NORTH FALLS

Offshore Wind Farm

Draft Marine Mammal Mitigation Protocol (~~Clean~~Tracked)

Document Reference: 7.7
Volume: 7
Date: July~~ne~~ 2025
Revision: 43

Plate 1.2 Proposed piling mitigation procedures.

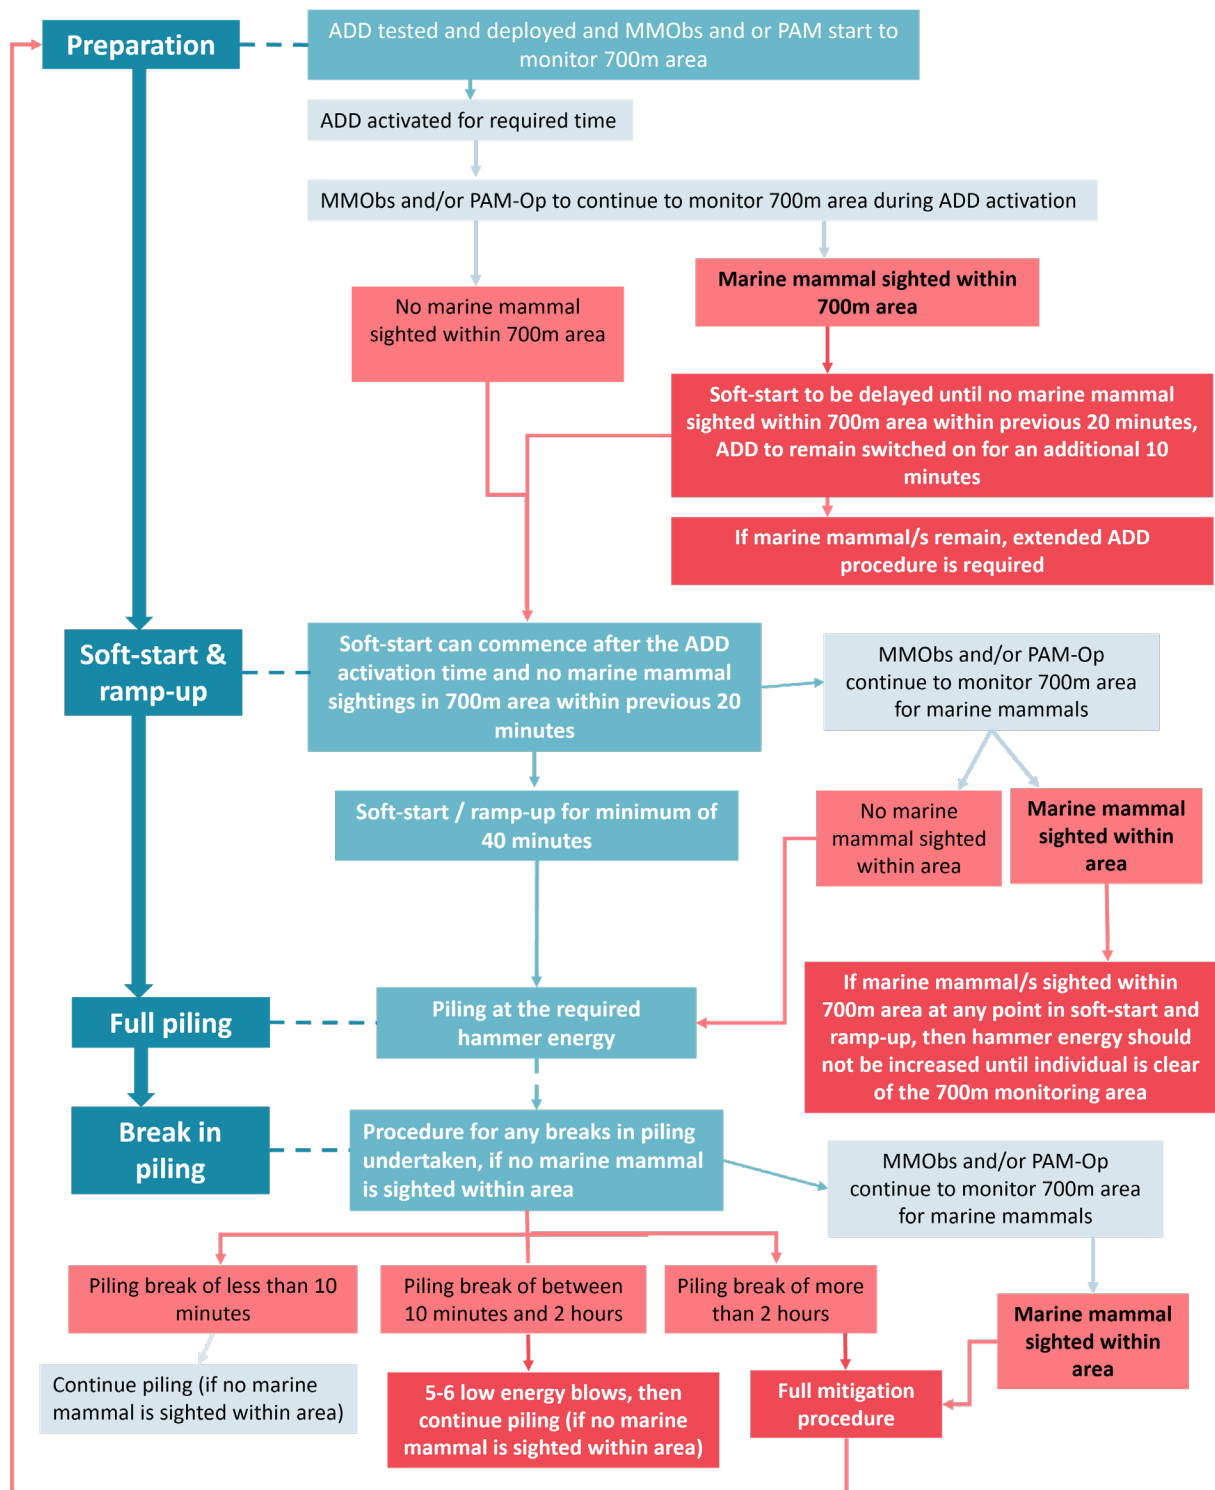
Natural England REP7-088	Table 1 1	We are content with the amendments of the Plate 1.2 as per our advice.	Noted, no further action required.
Natural England REP7-088	Table 1 2	Natural England notes that the Applicant has not accepted our advice on the use of Passive Acoustic Monitoring (PAM) for Unexploded Ordnance (UXO) clearance. The Marine Mammal Mitigation Protocol (MMMP) [REP6-030] still refers to this as 'unlikely to be required'. We also note the Applicant's response in E27 of Table 1.5 Examination Comments and Relevant Representations: "For UXO clearance the Applicant has committed to the use of PAM in instances when there are not favourable conditions with good visibility (sea state 3 or less)." Our advice remains that PAM is a required monitoring tool for UXO clearance especially given that the proposed development is	The Draft MMMP [REP6-029] contains details for how PAM will be utilised, as set out in Section 1.4.3.2.2. As per Natural England's request the text has been amended to ensure PAM, if required, will be used in conjunction with the MMObs for the UXO clearance mitigation procedures.

13. The Draft MMMP (Revision 3) includes updates to Plate 1.2 to ensure it matches the text regarding soft-start and ramp up procedures, and to make clear that piling will only continue after a break if there are no marine mammals present.

Appendix B. Plots for Comparable Hammer Strike Energies

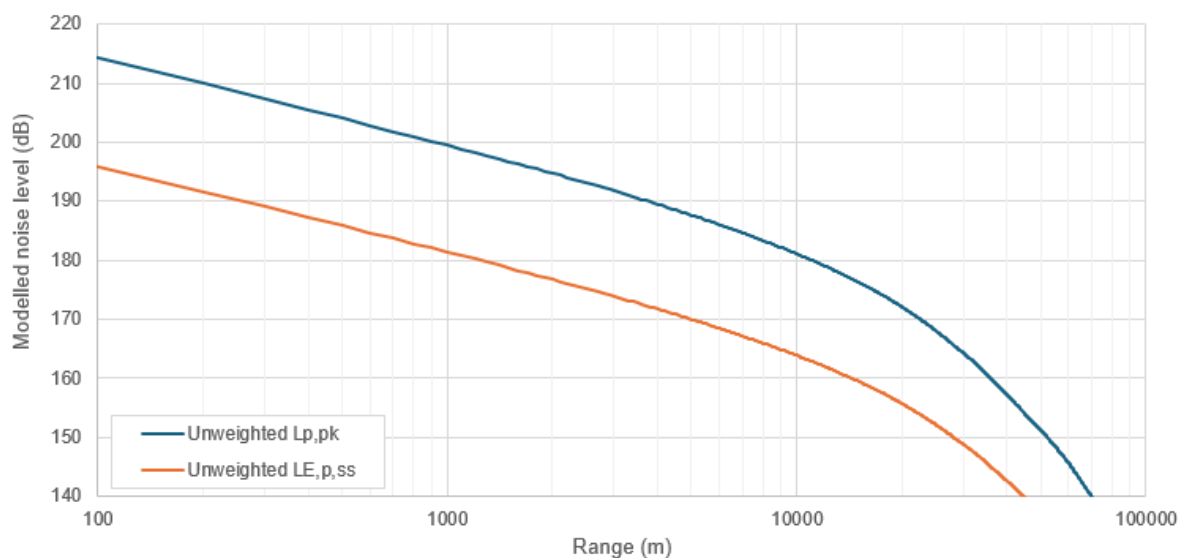
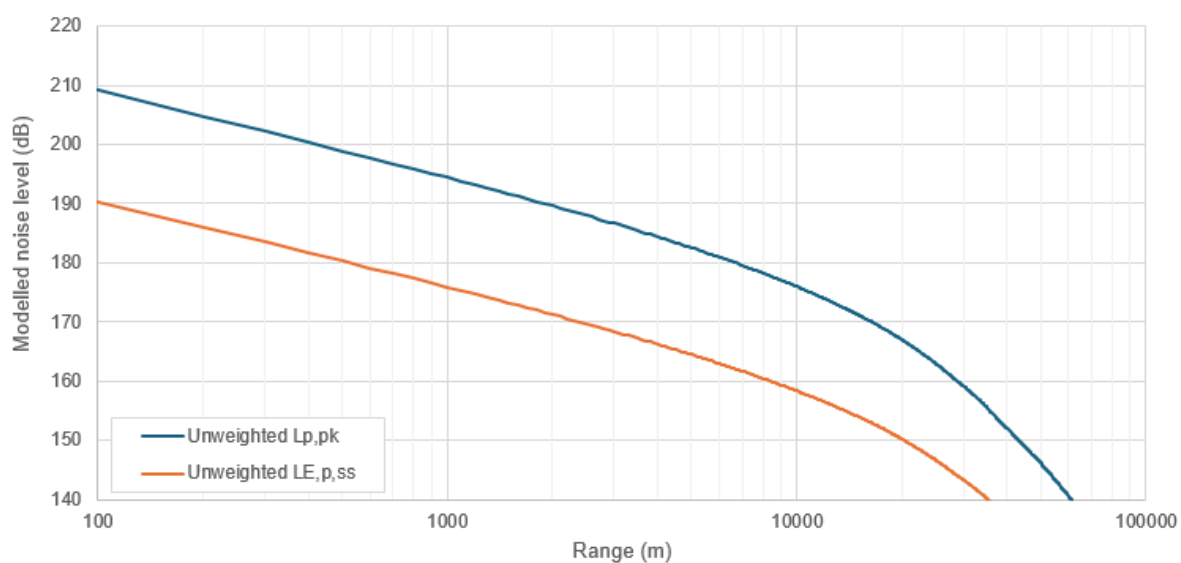
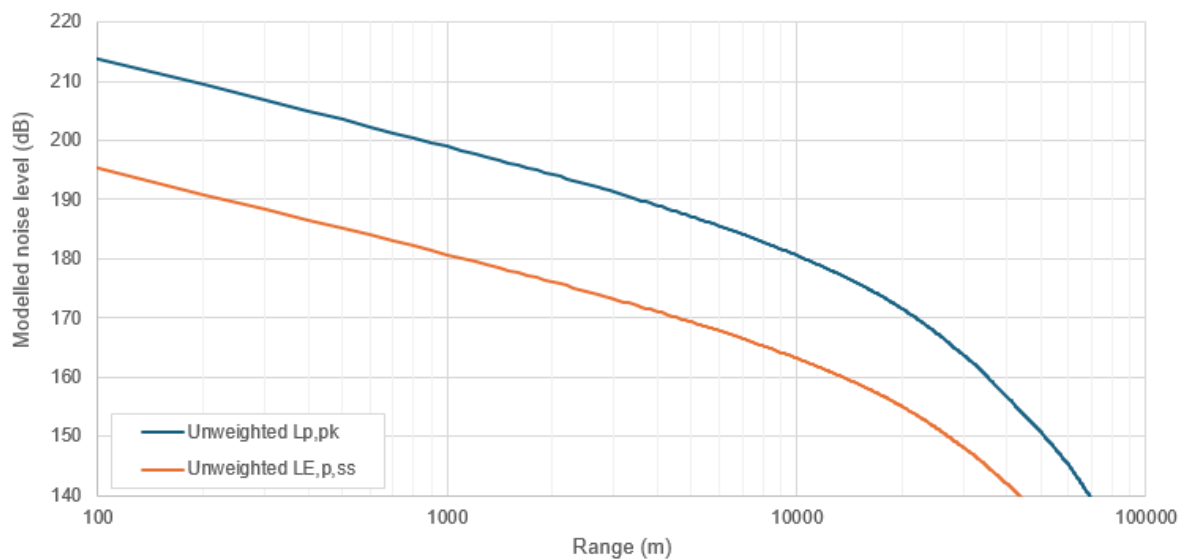
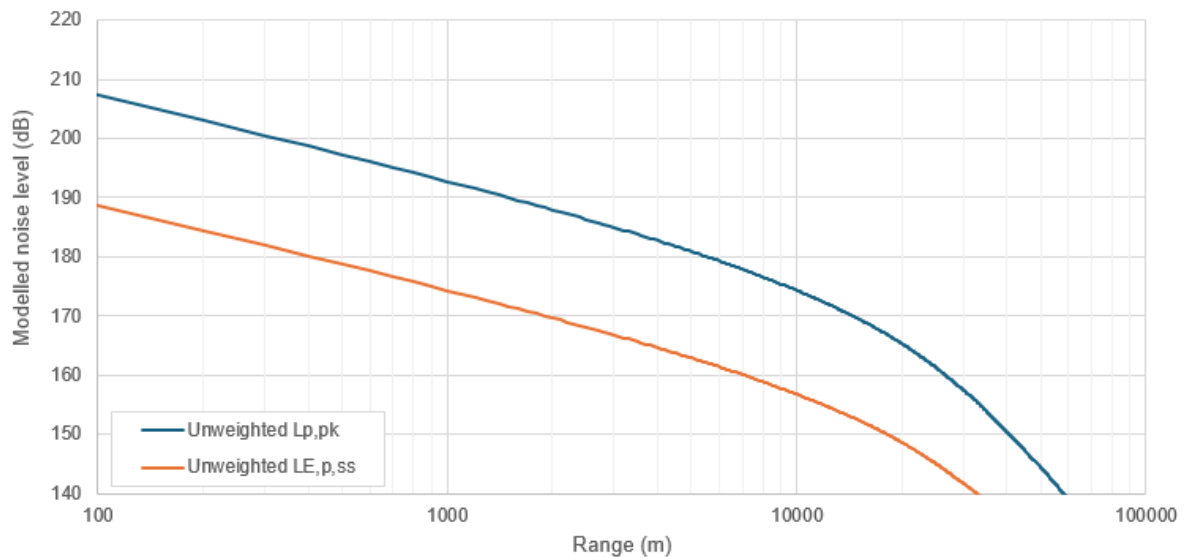
Consultee	Reference	Comment	Response / where addressed in the MMMP
		be required for a high-order clearance of a device of 120kg or higher.	
MMO	MMO-186	It is the understanding of the MMO that bubble curtains will be required for all high-order detonations, and this should be clear in the final MMMP. The MMO suggests that the Applicant consults with the specific UXO contractor to determine the appropriate parameters for safely deploying bubble curtains. If environmental conditions are not conducive to the use of a bubble curtain, then the MMO recommends postponing any high-order detonations until conditions are suitable.	As above in response to MMO-184.
MMO	MMO-195	The purpose of the noise monitoring during construction is to determine the actual underwater noise levels on site for comparison with the modelled levels presented in the ES. The MMO acknowledges that the measurements taken during installation will be constrained by various factors such as the piling plan and site limitations and a direct (like-for-like) comparison with a modelled scenario is unlikely to be possible. Nevertheless, even if the piling locations and choice of transects would not be matched precisely, both modelling and monitoring should provide enough information to deduce some envelope of received level curves in each case. Thus, some sort of comparison/s in the form of 'level vs range' plots (for comparable hammer strike energies), with the associated envelopes of variability, should be possible and would be expected. Therefore, the MMO recommends that such a plot is provided.	The Applicant has noted this comment from the MMO, therefore, these plots have been provided in Appendix B as part of the revised Draft MMMP (Revision 1).
